CODE CHANGES RESOURCE COLLECTION: 2009 IMC[®]

APPROVED CODE CHANGES RESULTING IN THE 2009 IMC[®]

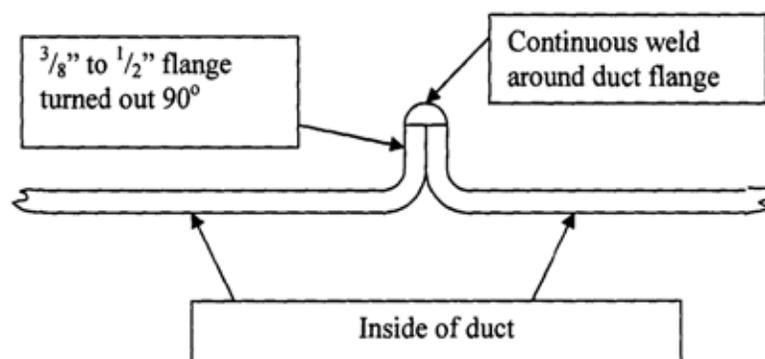
506.3.2.1 Duct joint types. Duct joints shall be butt joints, welded flange joints with a maximum flange depth of 0.5 inch (12.7 mm) or overlapping duct joints of either the telescoping or bell type. Overlapping joints shall be installed to prevent ledges and obstructions from collecting grease or interfering with gravity drainage to the intended collection point. The difference between the inside cross-sectional dimensions of overlapping sections of duct shall not exceed 0.25 inch (6 mm). The length of overlap for overlapping duct joints shall not exceed 2 inches (51 mm).

Reason: See the sketch below for a clarification of the proposed joint.
